KARACHI MUNICIPALITY.

Case No. P/8 318

PLAN OF PROPOSED BUILDING ON PLOT NO.54 SHEET NO.M.R.4

REFERENCE No. B. S. P. 318/33 OF 193

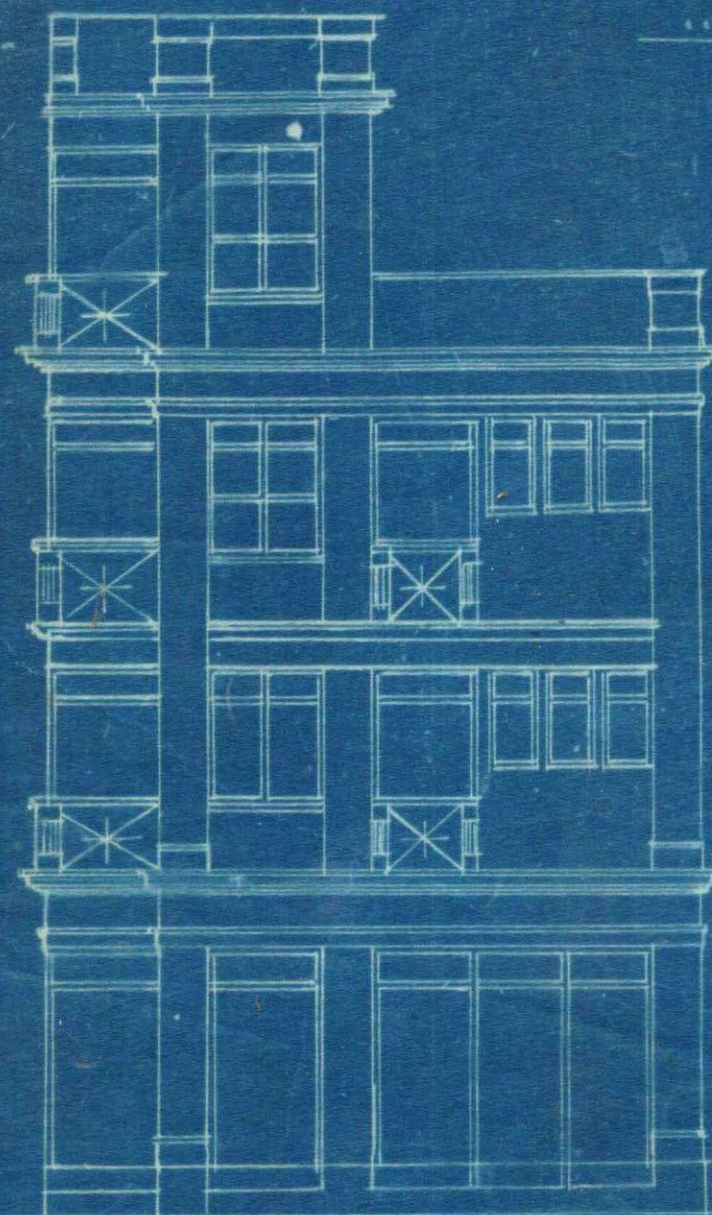
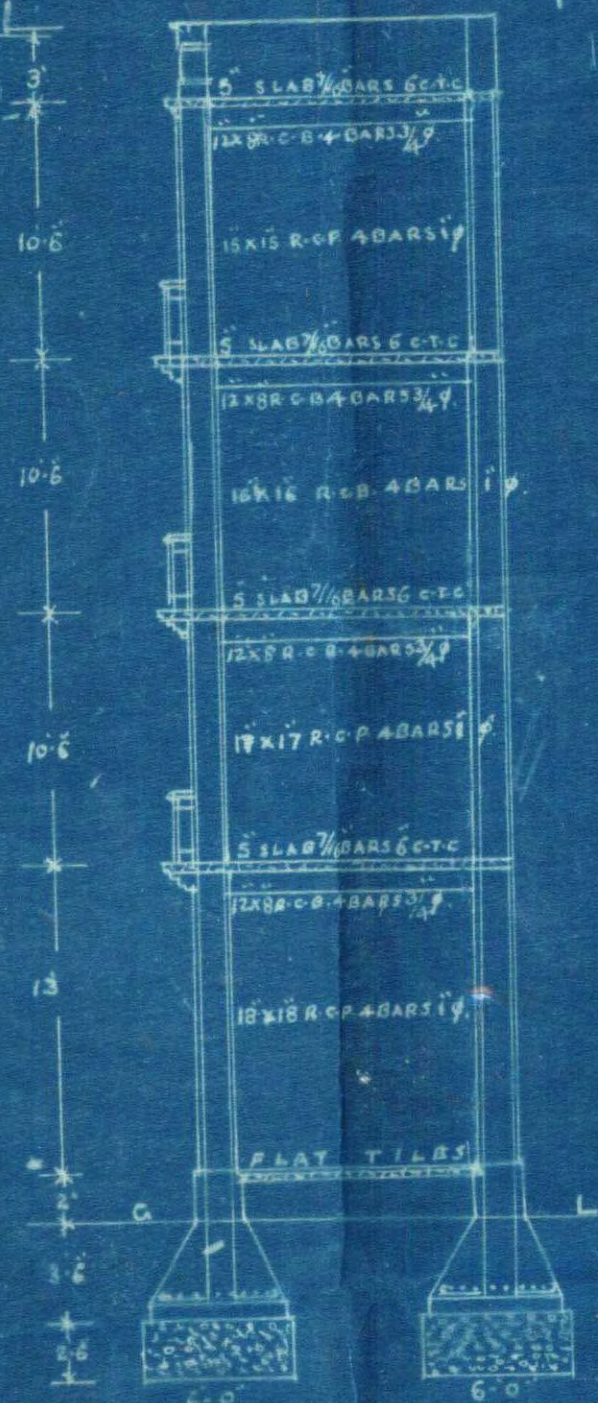
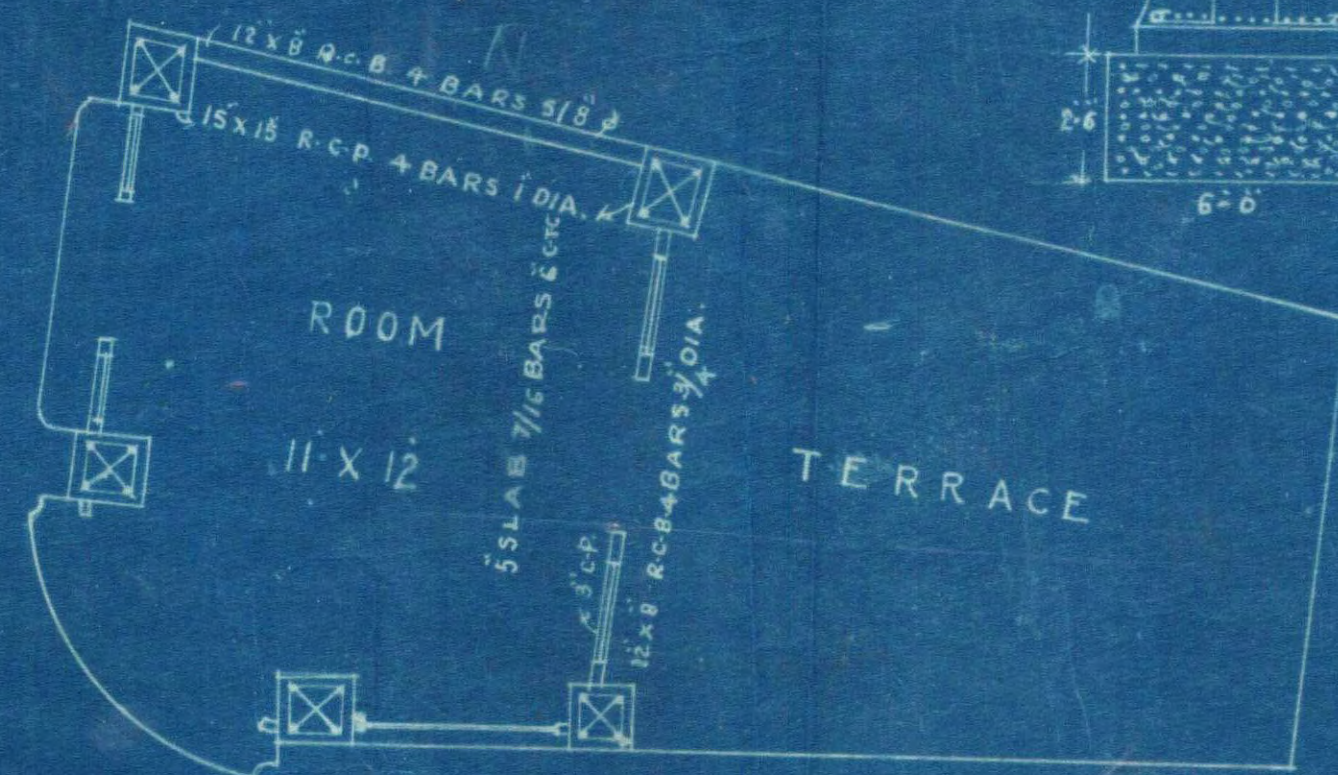
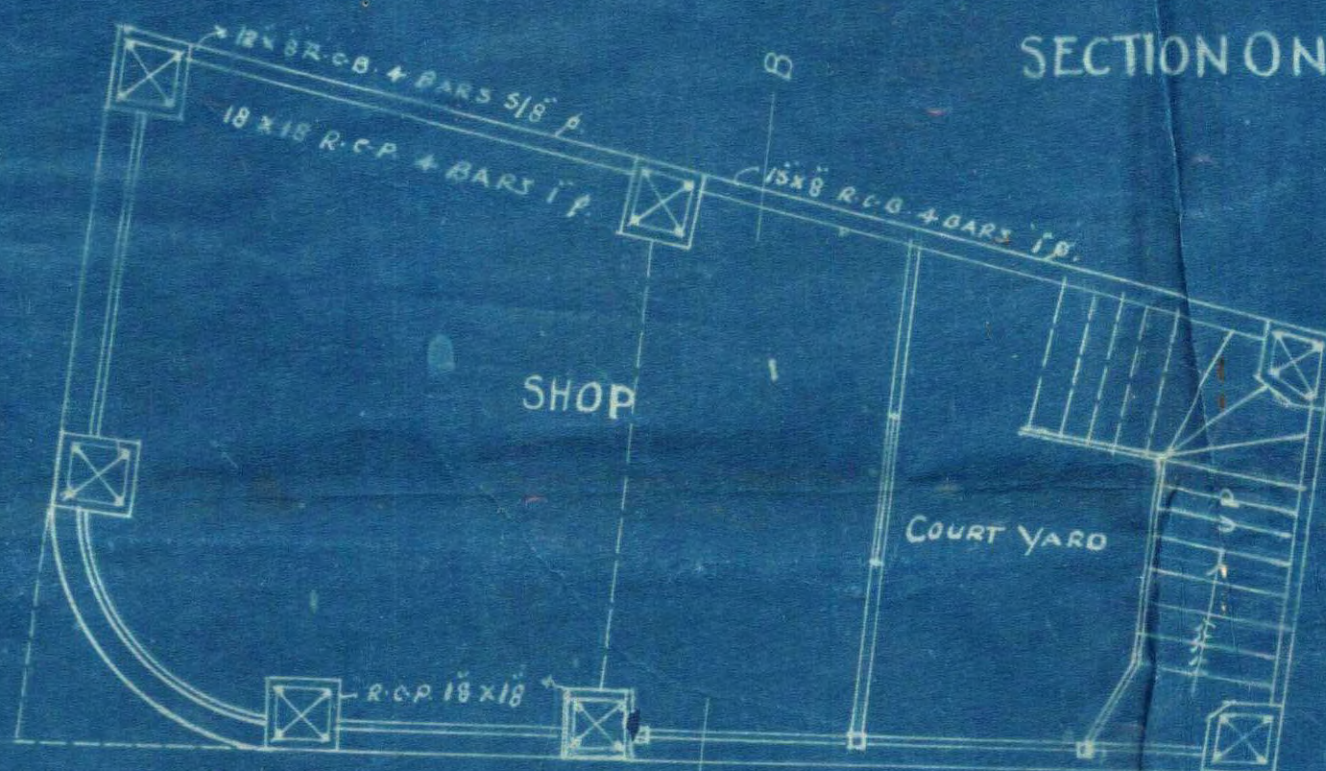
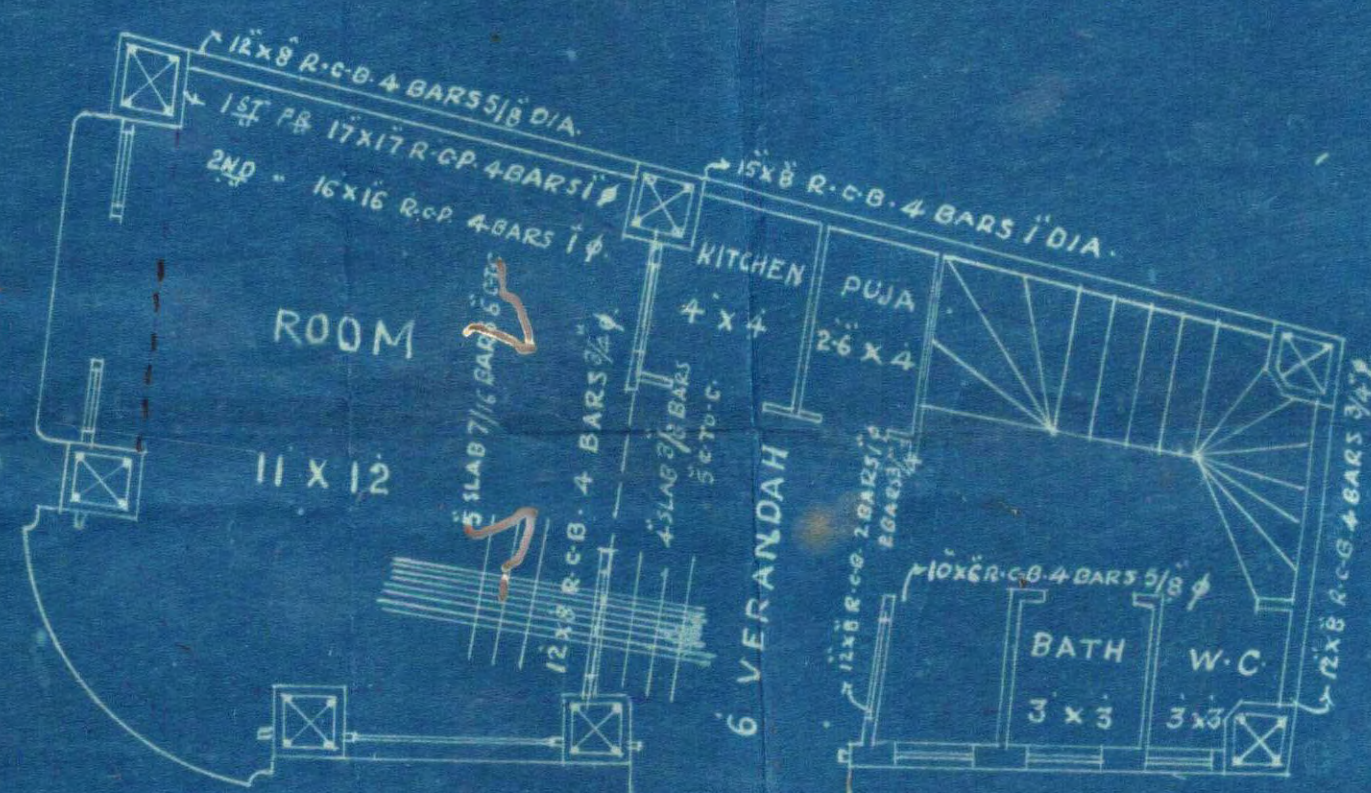
- 1) widths of the shik - he mentioned on the plan and the height of the building he regulated accordingly.
- 2) ~~the~~ 4 ft scale is unusual & misleading. Plan must be drawn on 8 ft scale.

- 3) R.C.C. pillars must be connected by all round ties.
- 4) Balconies must be 9"
- 5) Slab must be 5" $\frac{1}{2}$ " rod 5" c.c.
- 6) Load calculations for the R.C.C. pillars be given. as they must be 18 ft on 1st & 1st floor, 16 $\frac{1}{2}$ ft on 2nd floor & 15 ft on 3rd floor.

- 7) External walls must be at least 6" C.C.
- 8) W.C. on ground floor is required & so also generally in all places.
- 9) Kitchen must be 5 ft solid & barrier above.

- 10) Stairs must be fire proof.
- 11) Cornice must be limited to 12"
- 12) ^{calculation for} R.C.C. beam 12 x 8" 4 bars 3/4" diam which carries floor load of room & verandah & the subsidiary beams & partition load must be safe loaded.

- 13) ^{if form} must be completely filled.

- ✓ 1. Widths of the streets be mentioned on the plan and the height of the building be regulated accordingly.
- ✓ 2. 4ft ~~xxxxxx~~ scale is usual and misleading. Plan must be drawn on 8ft. scale.

- ✓ 3. R.C.C. pillars must be connected by all round lintels
- ✓ 4. Balconies must be 9".
- ✓ 5. Slab must be 5" 1/2 rods 5" C.C.
- ✓ 6. Load calculations for the R.C.C. pillars be given, or they must be 18"X18" on ground and 1st floor, 16 1/2"X16 1/2" on 2nd floor on 3rd floor it should be 15"X15".

- ✓ 7. External walls must be least 6" C.P.
- ✓ 8. W.C. on ground floor is required and so also general washing place.
- ✓ 9. Kitchen must be 5ft solid and barred above.

- ✓ 10. Stairs must be fireproof.
- ✓ 11. Cornice must be built to 12".
- ✓ 12. Calculations for R.C.C. beam 12"X24" 4 bars 1" diam which carries floor load of room and verandah and the subsidiary beams and partition load must be submitted.

- ✓ 13. A form must be completely filled

1. Objections 1, 3-7, 9-11 and 13 are complied with.
2. As regards no. 2, 4 feet to an inch scale is most convenient for very small plots, as otherwise the plans would be very confusing.
3. As regards no. 8, the washing place is provided, but as regards the W.C. the shop is to be used by the owner himself who shall also use the upper floors for residence, each floor is provided with a W.C.
4. Calculations are given herewith.
